Amendment No. 0009  
12 February 2003

SUBJECT: Amendment No. 0009 to Specifications and Drawings for Construction of  
Irrigation Intake/Sloughing Easements For Flow Modification,  
Fort Peck, MT  
Solicitation No. DACW45 01 B 0007.

**IRRIGATION INTAKES/SLOUGHING EASEMENTS FOR FLOW MODIFICATION  
FORT PECK, MT**

Sheet reference number: P1.02A

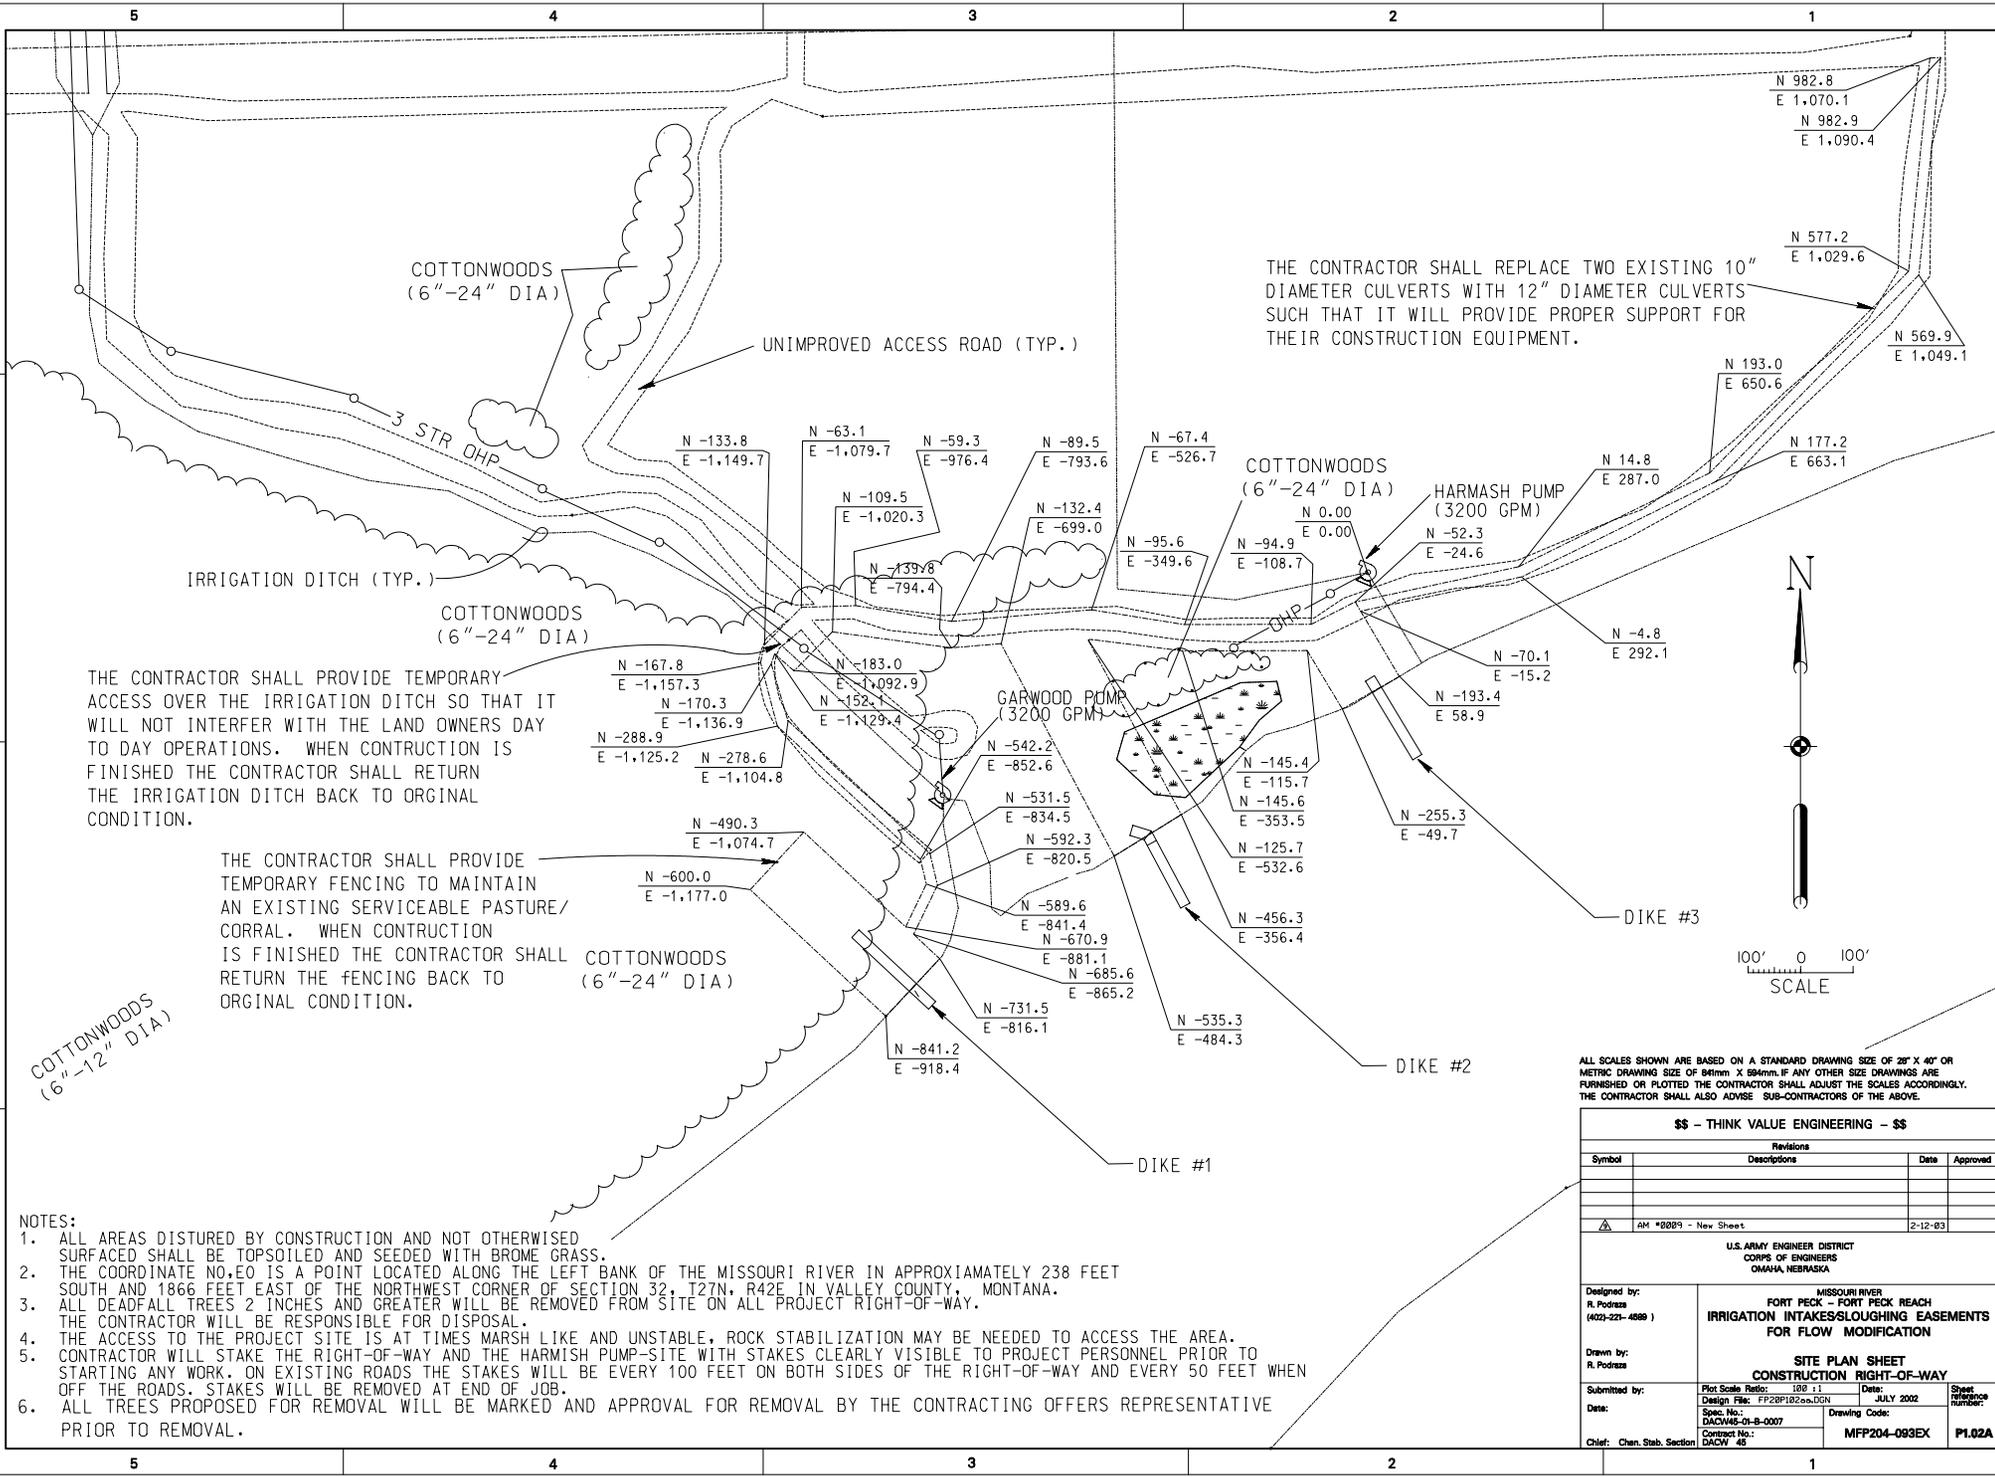
THE CONTRACTOR SHALL REPLACE TWO EXISTING 10" DIAMETER CULVERTS WITH 12" DIAMETER CULVERTS SUCH THAT IT WILL PROVIDE PROPER SUPPORT FOR THEIR CONSTRUCTION EQUIPMENT.

THE CONTRACTOR SHALL PROVIDE TEMPORARY ACCESS OVER THE IRRIGATION DITCH SO THAT IT WILL NOT INTERFERE WITH THE LAND OWNERS DAY TO DAY OPERATIONS. WHEN CONSTRUCTION IS FINISHED THE CONTRACTOR SHALL RETURN THE IRRIGATION DITCH BACK TO ORIGINAL CONDITION.

THE CONTRACTOR SHALL PROVIDE TEMPORARY FENCING TO MAINTAIN AN EXISTING SERVICEABLE PASTURE/ CORRAL. WHEN CONSTRUCTION IS FINISHED THE CONTRACTOR SHALL RETURN THE FENCING BACK TO ORIGINAL CONDITION.

**SPUR DIKE  
TYPICAL SECTION**  
NO SCALE

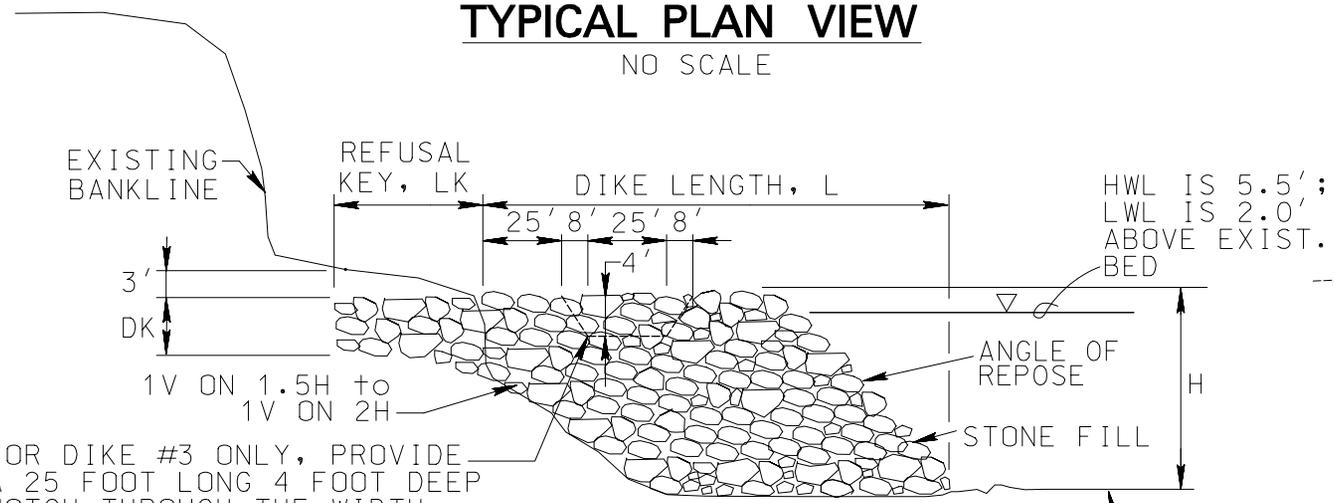
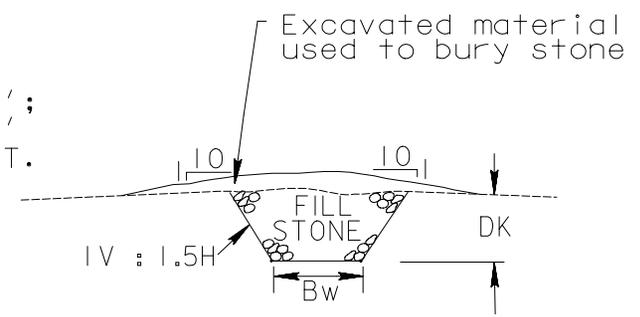
FOR DIKE #3 ONLY, PROVIDE A 25 FOOT LONG 4 FOOT DEEP NOTCH THROUGH THE WIDTH OF THE DIKE. THE TW FOR THE LANDWARD SIDE OF THE NOTCH WILL BE 10' WIDE. THE TW ON THE RIVER SIDE OF THE NOTCH WILL BE 5' WIDE.

STRUCTURE	LENGTH, L**	SPACING, S	HEIGHT, H	A1	A2	WIDTH, Tw	REFUSAL KEY, LK ***	WIDTH, Bw	REFUSAL KEY, DK	STONE, tons	
DIKE 1	50'	525'	6'	90°	90°	5'	150'	5'	6.5'	1101	△1
DIKE 2	150'		8'	90°	135°	5'	36'	5'	6.5'	1413	△1
DIKE 3	150'		8'	90°	90°	10' & 5' △9	25'	5'	6.5'	1351	△1
